APP/15/01027/LIS– Dairy Cottage, 23 Claremont Gardens, Waterlooville
PO75LI

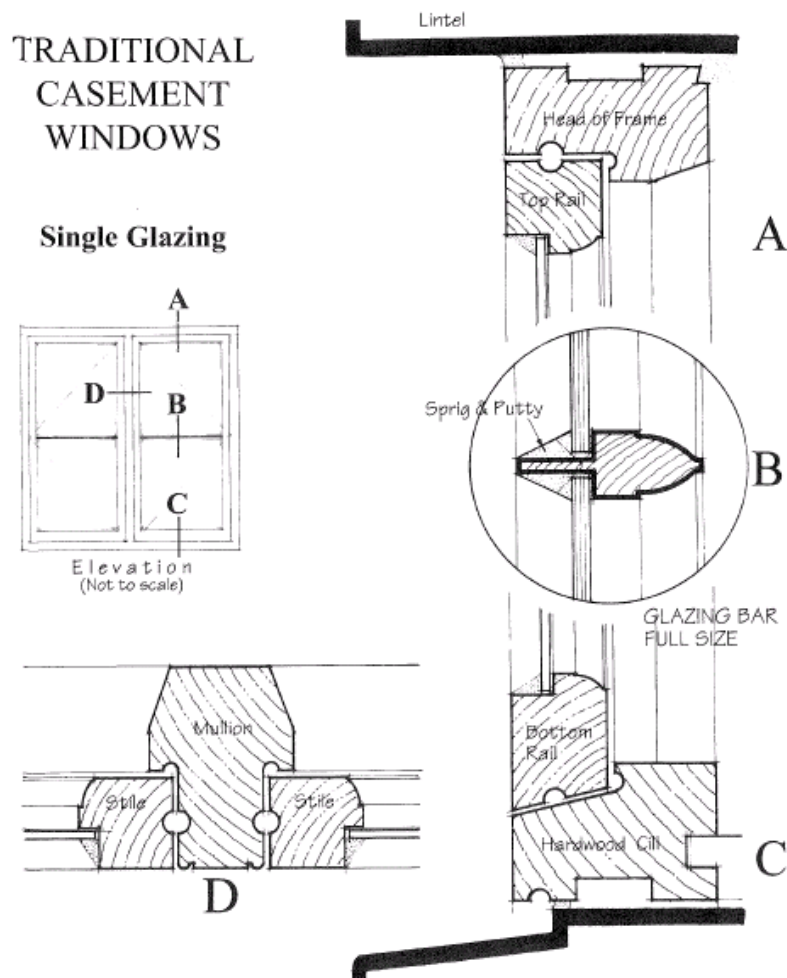
The overall design is acceptable and I note the joinery details are based on those approved for the dormers. I suggest the glazing bar could be improved and made slimmer without impacting on the overall design. The approved glazing bars are akin to what is used in double glazing. Below is an illustration of what I consider more appropriate.

The advantage is that the glazing bar is slimmer, more historically accurate, and for the occupant less apparent in views out. Given what has previously

been permitted this is not a make or break point, but if revised in the form shown, I feel it would be of mutual benefit. Further information about windows in listed building can be found in “Windows in Listed Buildings and Conservation Areas – Guidance Note” available to download from the website – see [link](#).
